**IOWA DEPARTMENT OF TRANSPORTATION**

**TO OFFICE:** District 4  
**ATTENTION:** Wes Mayberry  
**FROM:** Alfred Benesch & Company  
**OFFICE:** Design  
**SUBJECT:** Field Exam (D-2)

**DATE:** March 16, 2018  
**REF.:** Pottawattamie County  
IMX-029-4(112)72--02-78  
BRFIMX-029-4(113)72--14-78  
PIN: 16-78-029-070

A field exam was held on Thursday, February 1, 2018, to review the proposed plan for the bridge replacement at County Road G12 over I-29 in Pottawattamie County.

COUNTY ROAD G12  
PROFILE

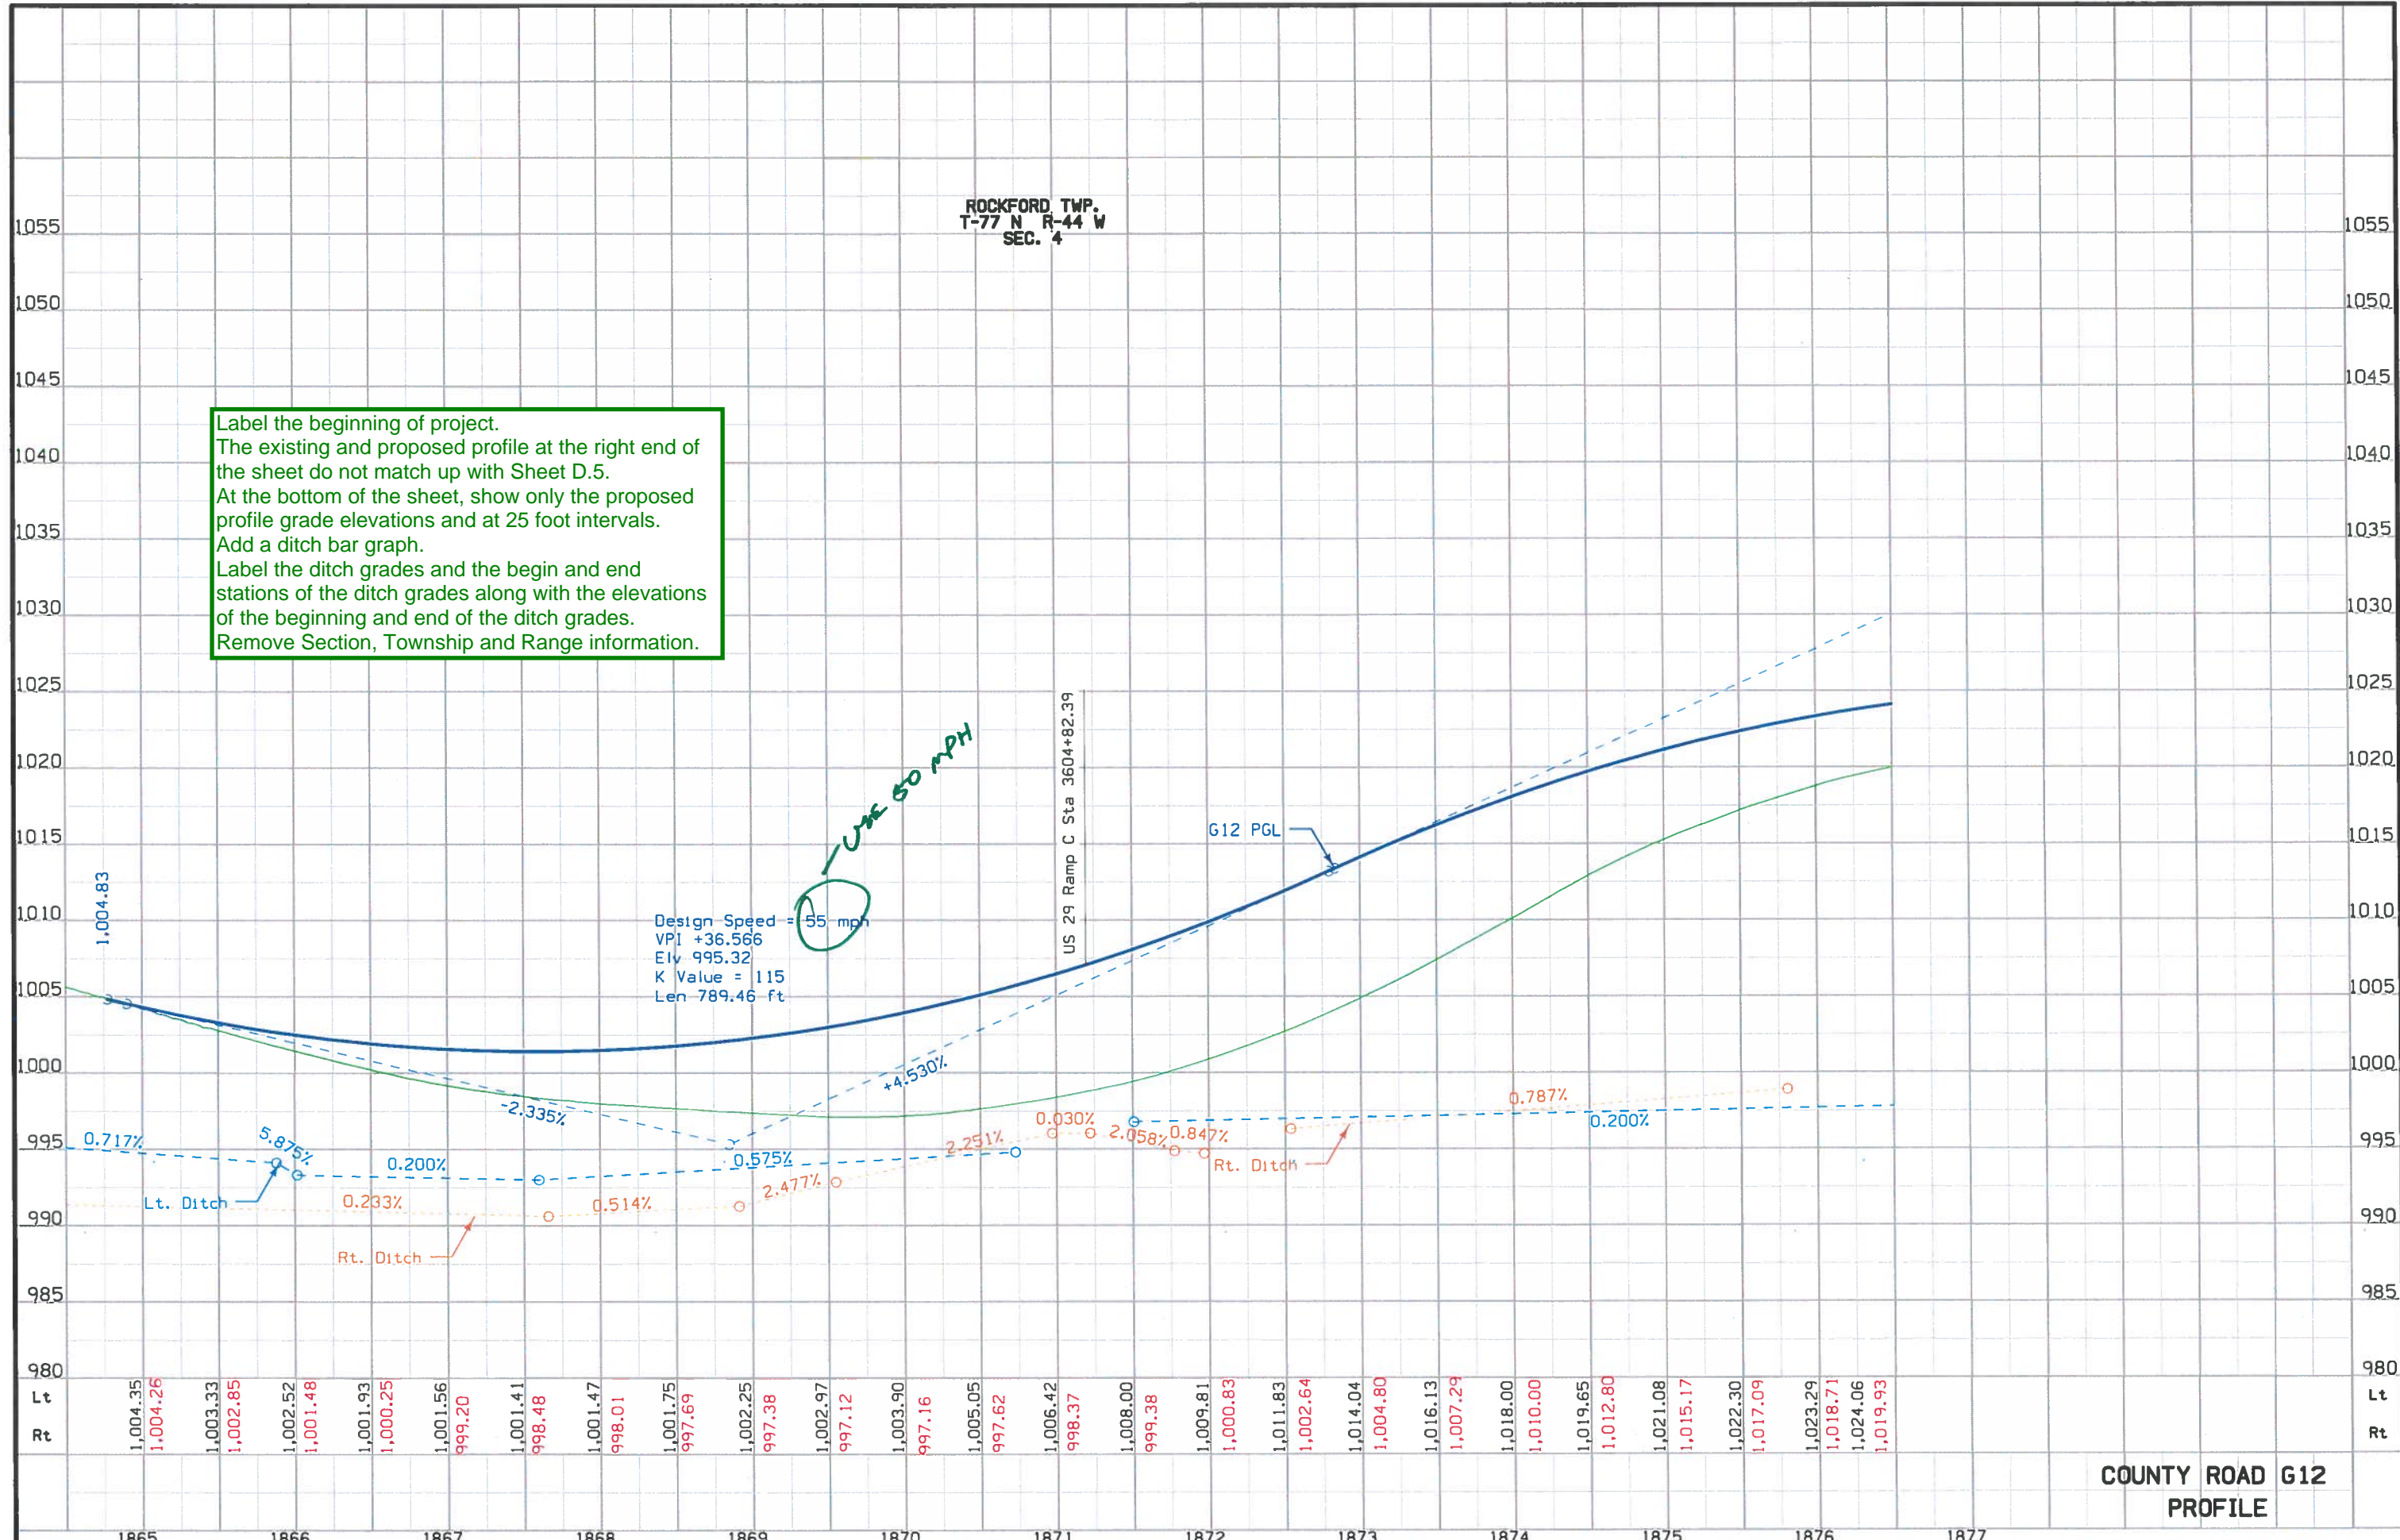
Label the beginning of project.  
The existing and proposed profile at the right end of the sheet do not match up with Sheet D.5.  
At the bottom of the sheet, show only the proposed profile grade elevations and at 25 foot intervals.  
Add a ditch bar graph.  
Label the ditch grades and the begin and end stations of the ditch grades along with the elevations of the beginning and end of the ditch grades.  
Remove Section, Township and Range information.

Label the end of project.  
 Same comments as Sheet D.2.  
 Label Commercial Building at gas station.  
 Label entrance stations.  
 Label "Proposed Type B Entrances."  
 Label "Closed" on entrance to be closed.  
 Give station for existing and proposed bridge.

COUNTY ROAD G12  
 PLAN

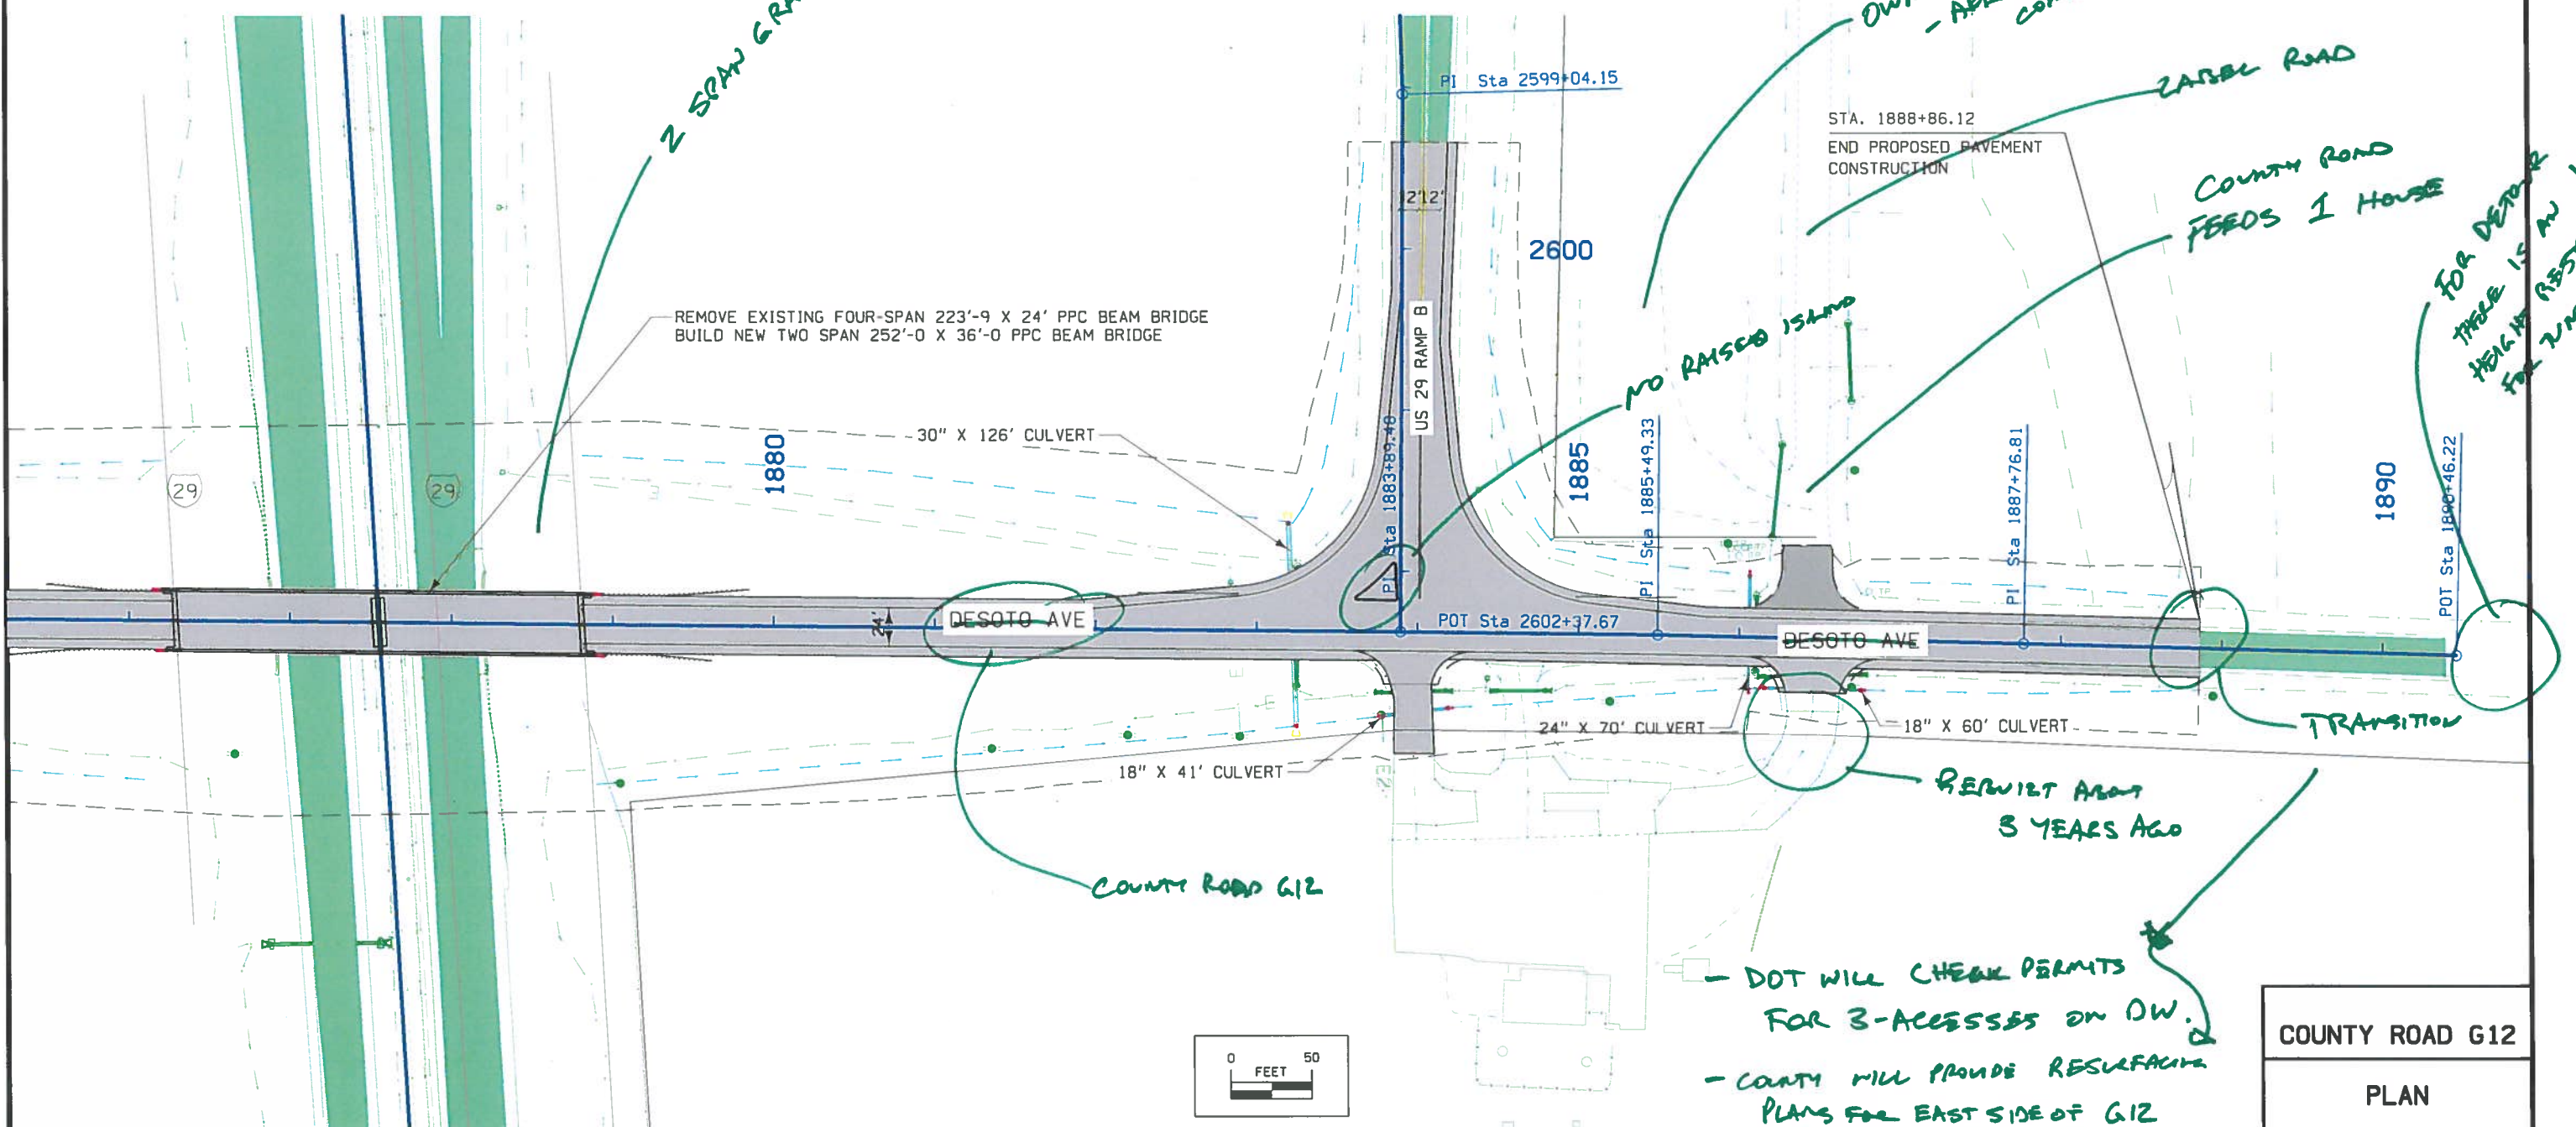
ZARBE ROAD  
 COUNTY ROAD  
 FEEDS 1 HOUSE

FOR DETOUR  
 THERE IS AN 11'  
 HEIGHT RESTRICTION  
 FOR TUNNEL

- DOT WILL CHECK PERMITS  
 FOR 3-ACCESSES ON DW.  
 - COUNTY WILL PROVIDE RESURFACING  
 PLANS FOR EAST SIDE OF G12

G12 AND RAMPS  
DETOUR PAVEMENT

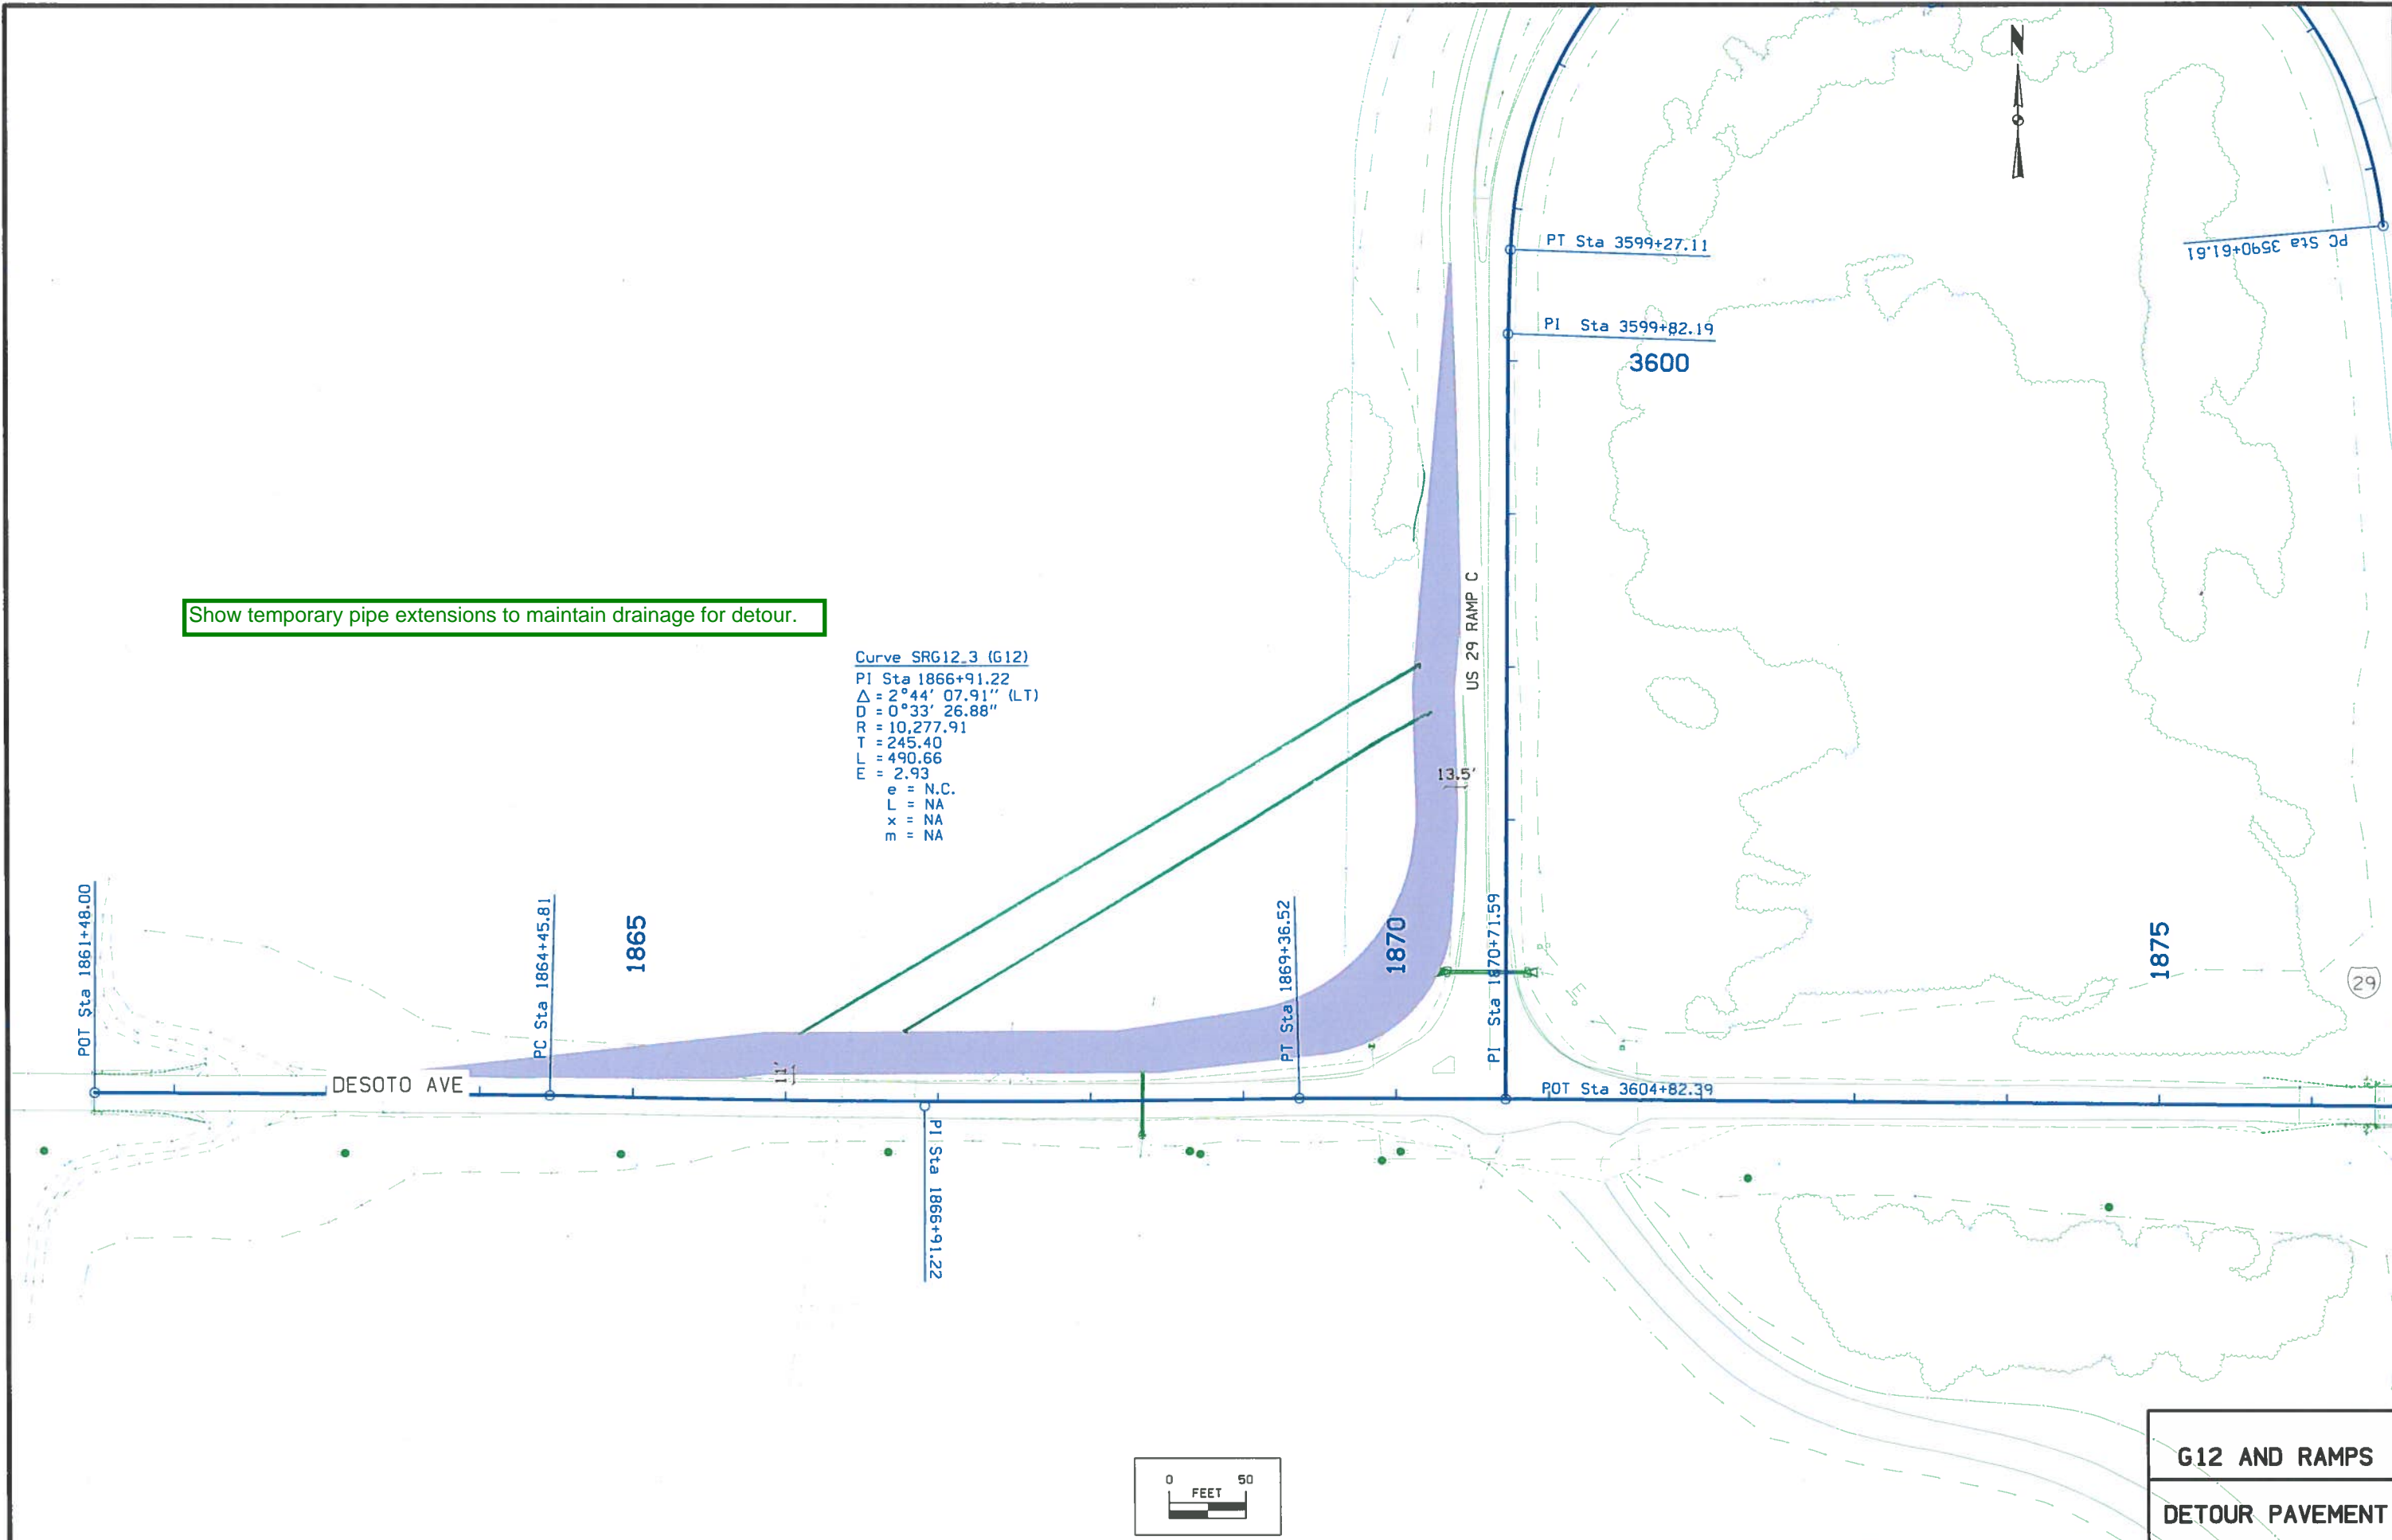
Show temporary pipe extensions to maintain drainage for detour.
